WORLD WAR II MEMORIAL: FDR D-DAY PRAYER DESIGN DEVELOPMENT

MAY 20, 2021

PRESENTATION TO THE
COMMISSION OF FINE ARTS

Revised Planting Design

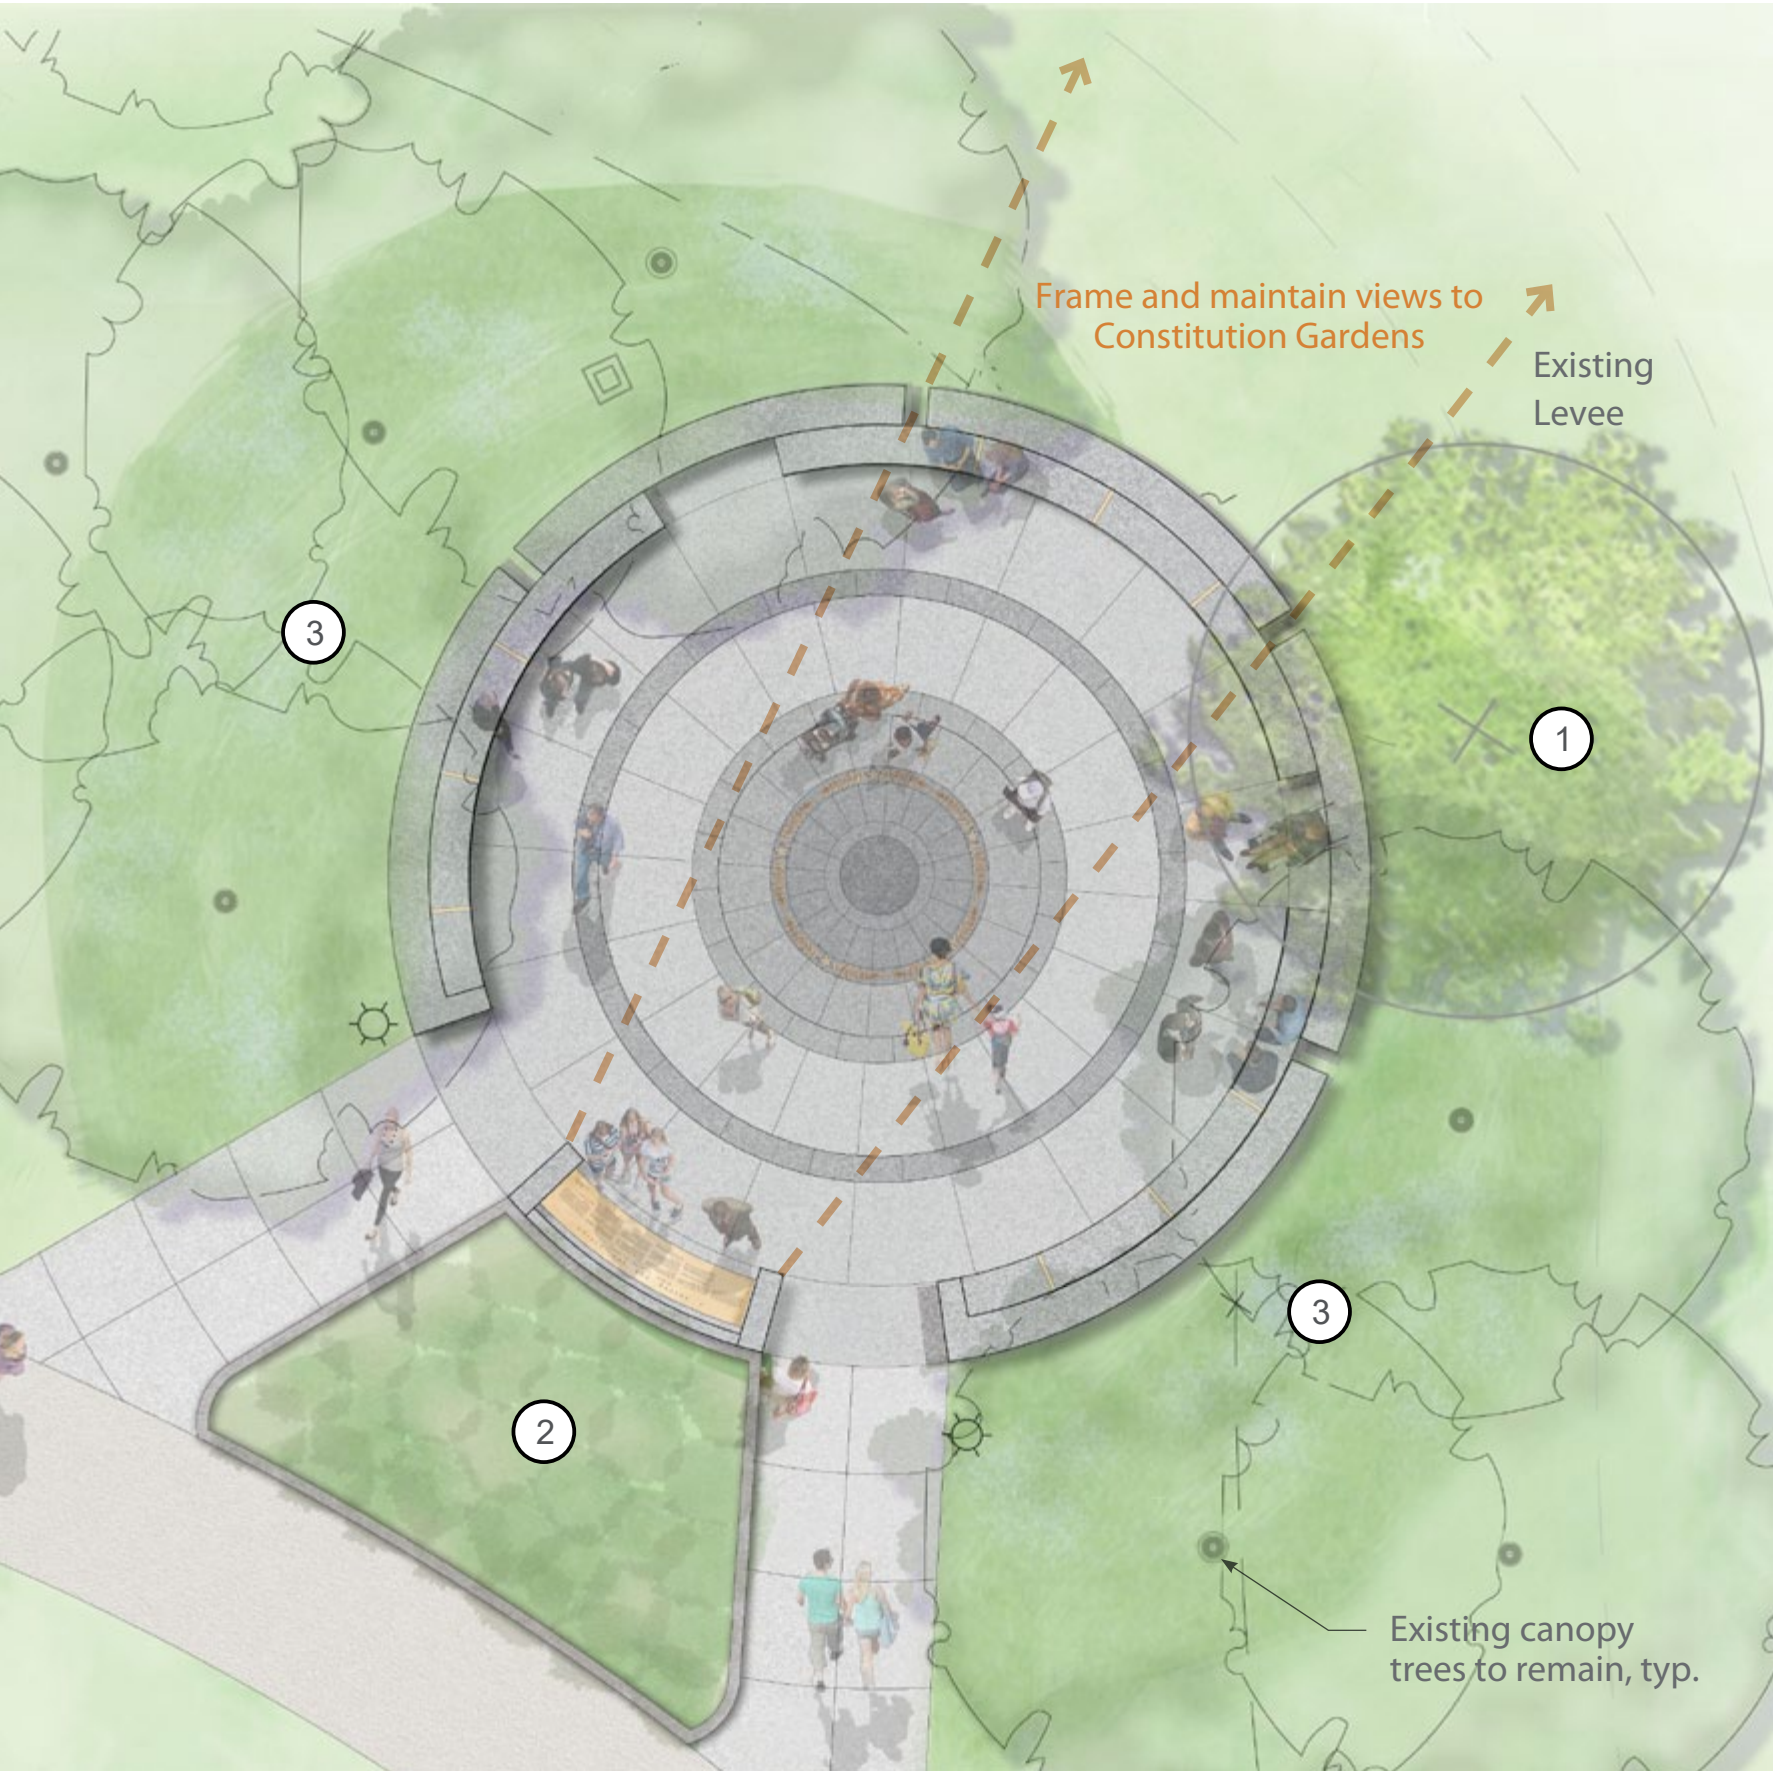
“simplifying the plantings...to unify the site with the larger landscape of the war memorial”

- Retain existing trees
- Place (1) additional Chionanthus retusus to balance design
- Low evergreen shrubs at entry: Sarcococca hookeriana var. humilis

① Additional Chionanthus retusus to match existing multi-stem trees

② Front Entry Shrub: Sarcococca hookeriana var. humilis

③ Groundcover under trees: Carex species

Bench Studies

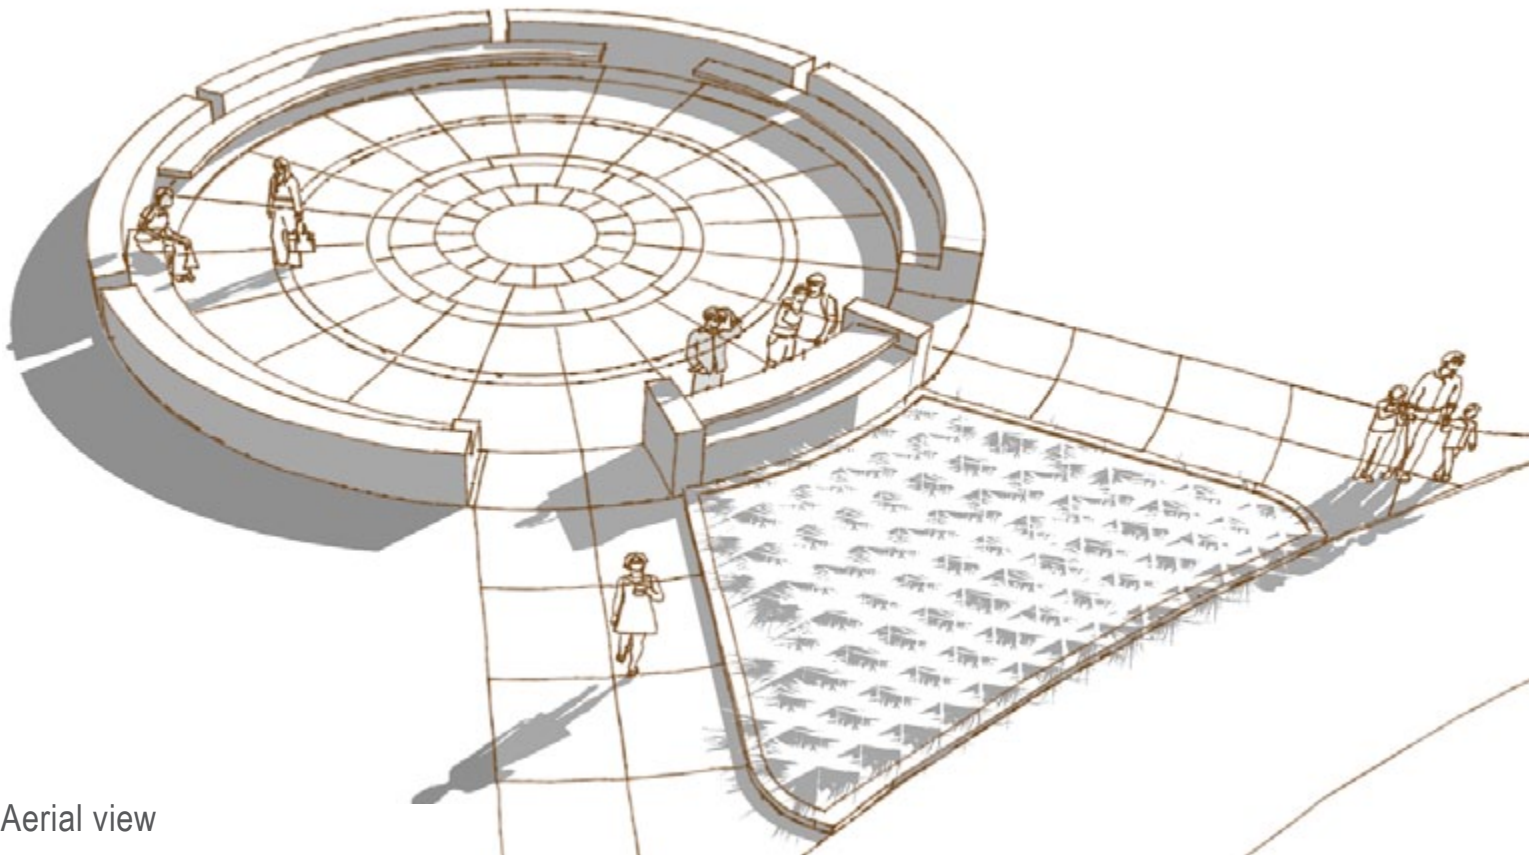
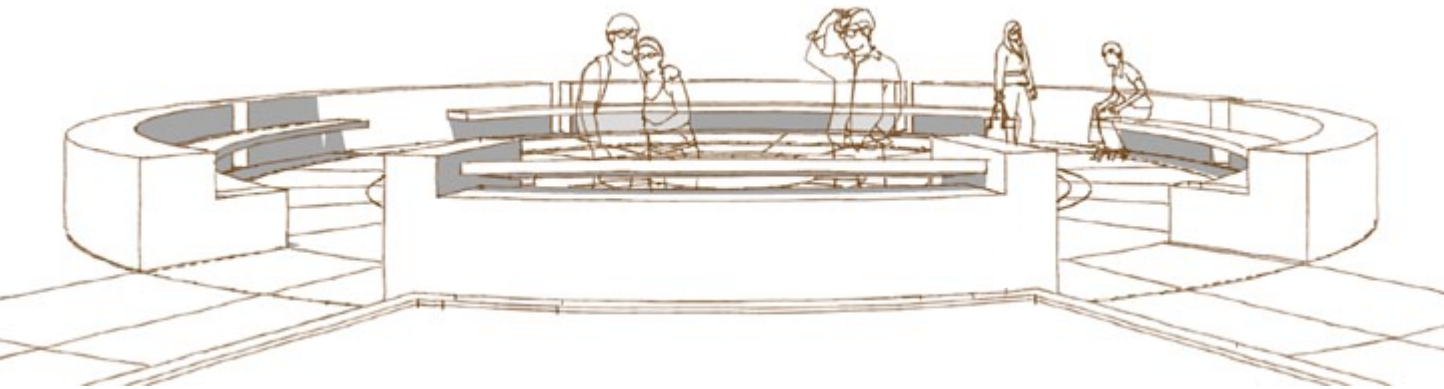
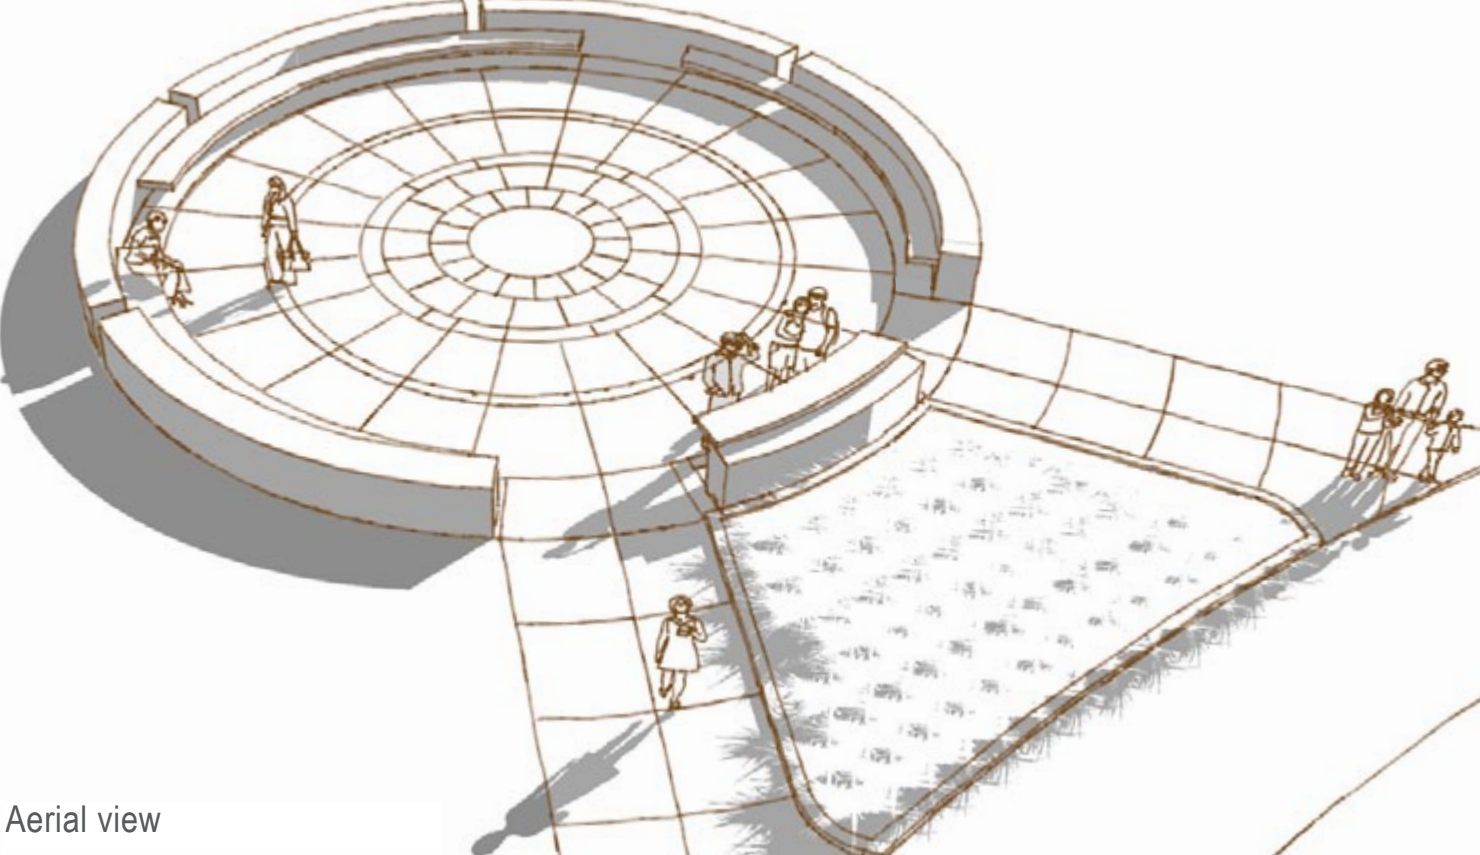
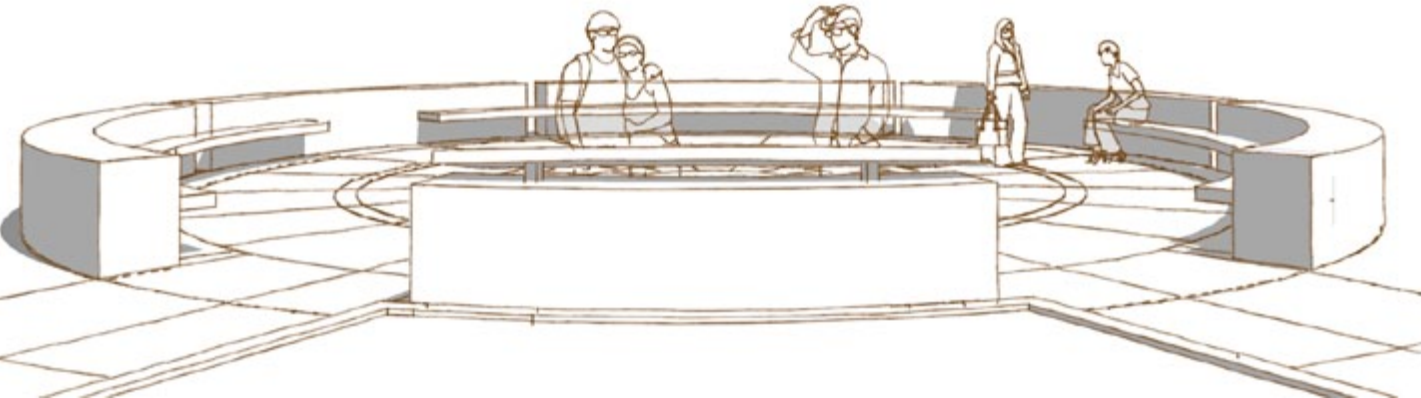
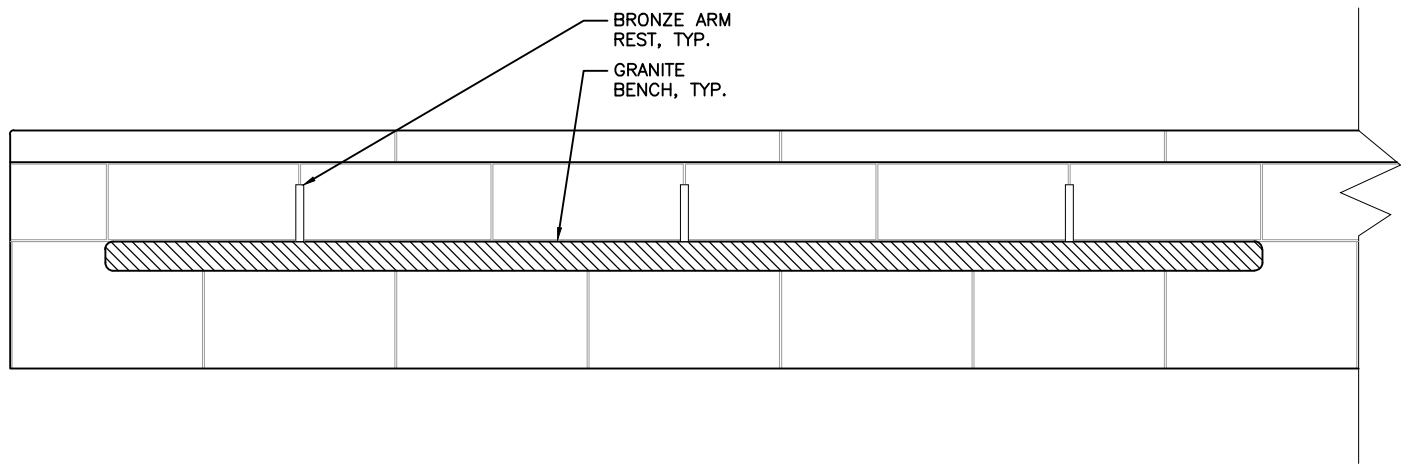
Commission Comment: “the design of the perimeter benches be less blocky in character, perhaps more carefully related to the benches within the...memorial.”

- Alternative A | Original design modified: site walls stepped down at entry, pillars and benches refined
- Alternative B | Alternative design: pillars removed, Prayer and benches ‘float’

Alternative B 'Floating' Plaque Concept and Revised Inscription

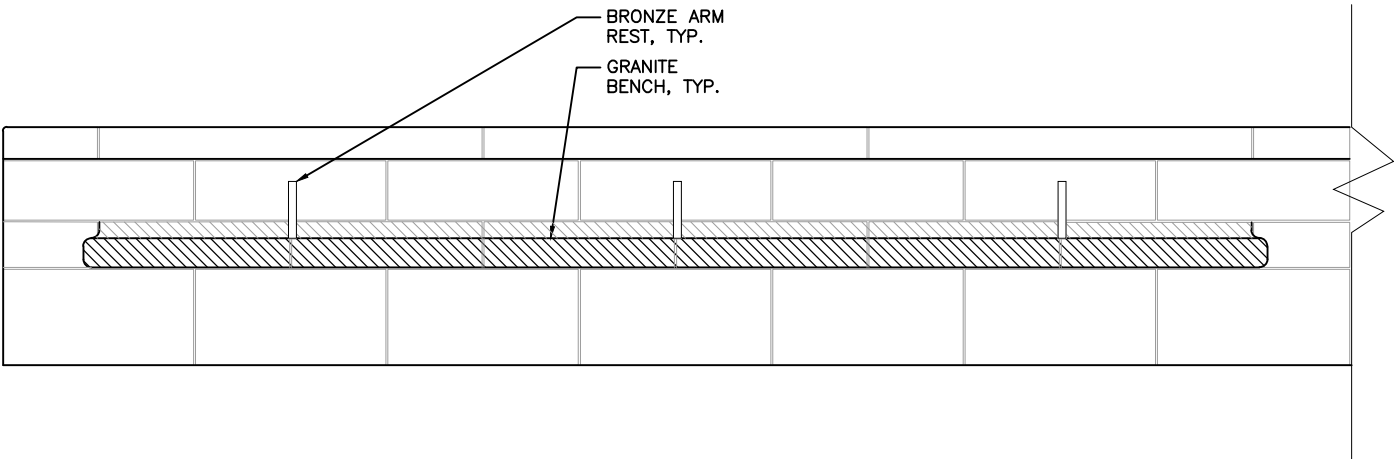
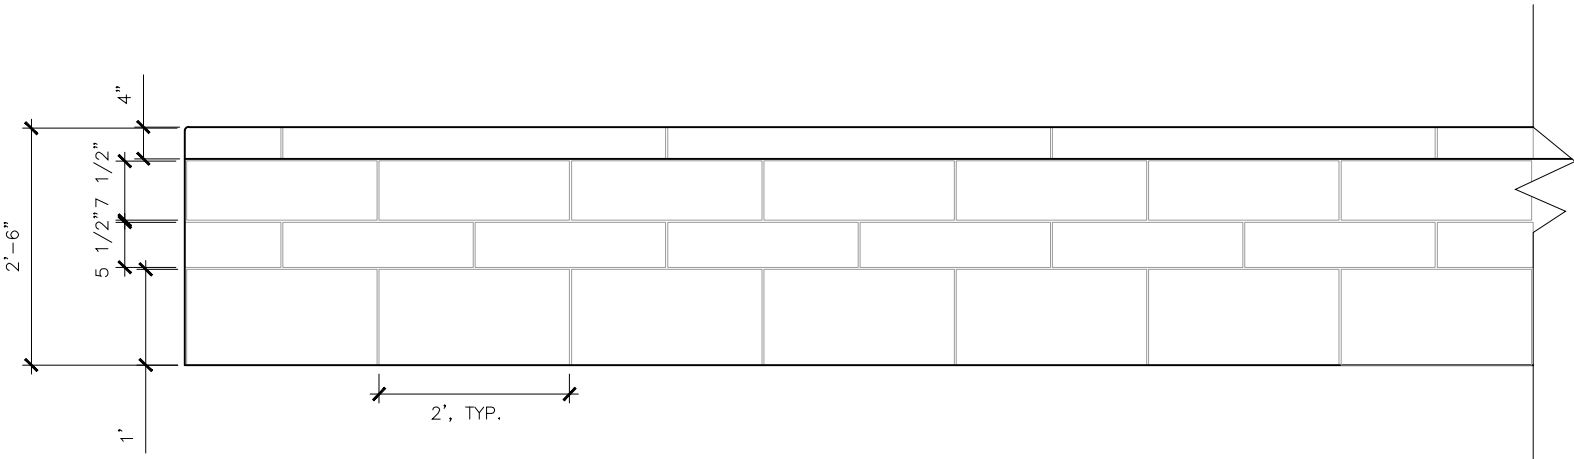
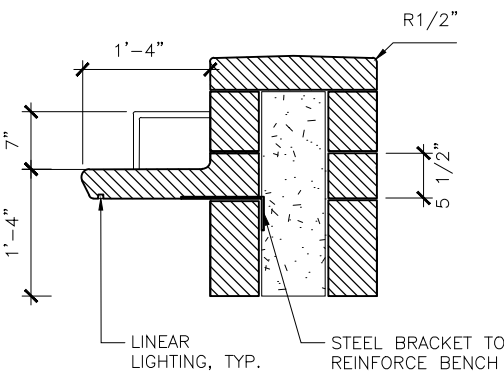
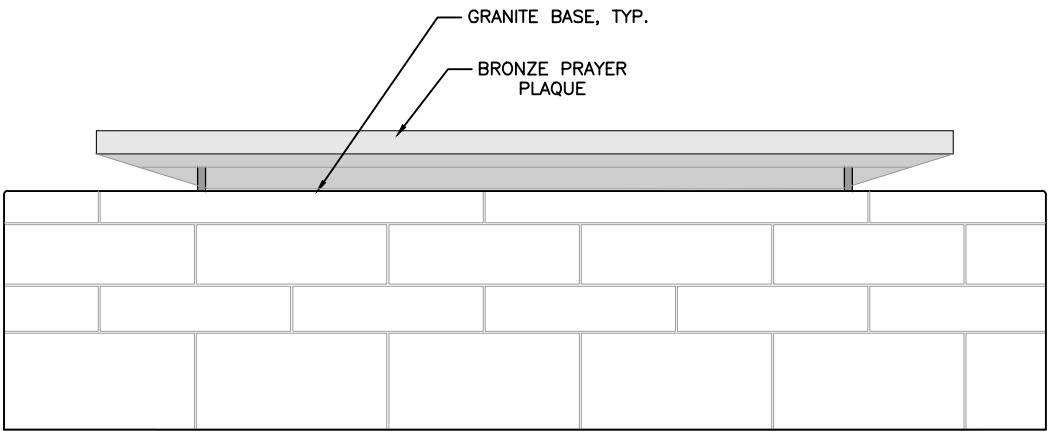
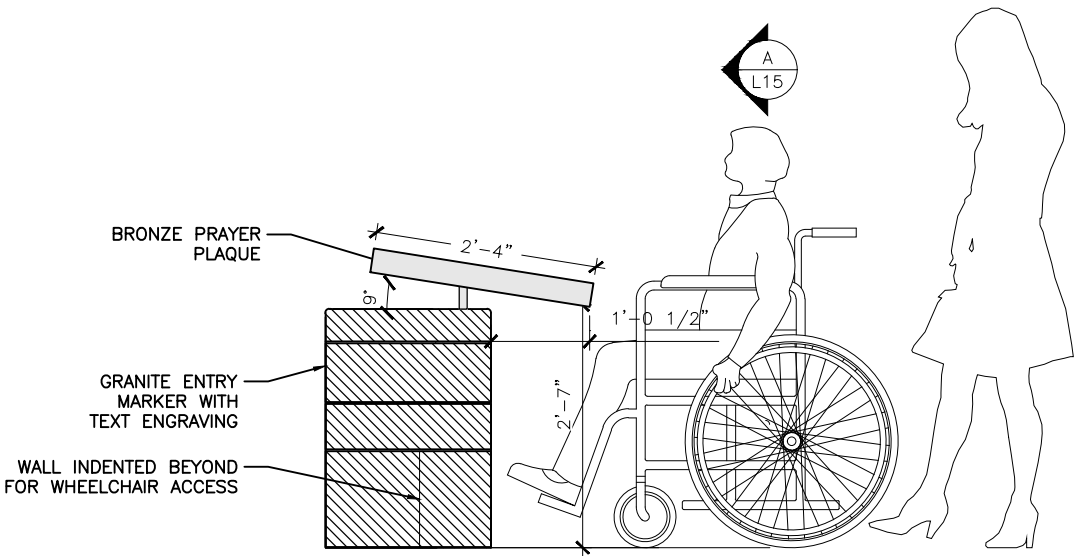
Commission Comments: “reducing the height of the flanking piers to align with the backs of the benches; this would allow the bronze plaque to visually float above a consistent stone base” and a “...simpler inscription, such as “June 6, 1944” or graphic symbols such as stars, to indicate the theme of the circle”

- Pillars eliminated and plaque is supported by dark metal frame from below
- Granite enframement has been lowered to 30” to match site walls
- In consultation with the National Park Service, D-Day with the date is preferred

- Granite enframement has been lowered to match 30" height of site walls
- Prayer plaque is supported by dark metal frame below
- Medallion revised to incorporate non-directional design
- Bench profile sculpted and refined to recall WWII Memorial detail
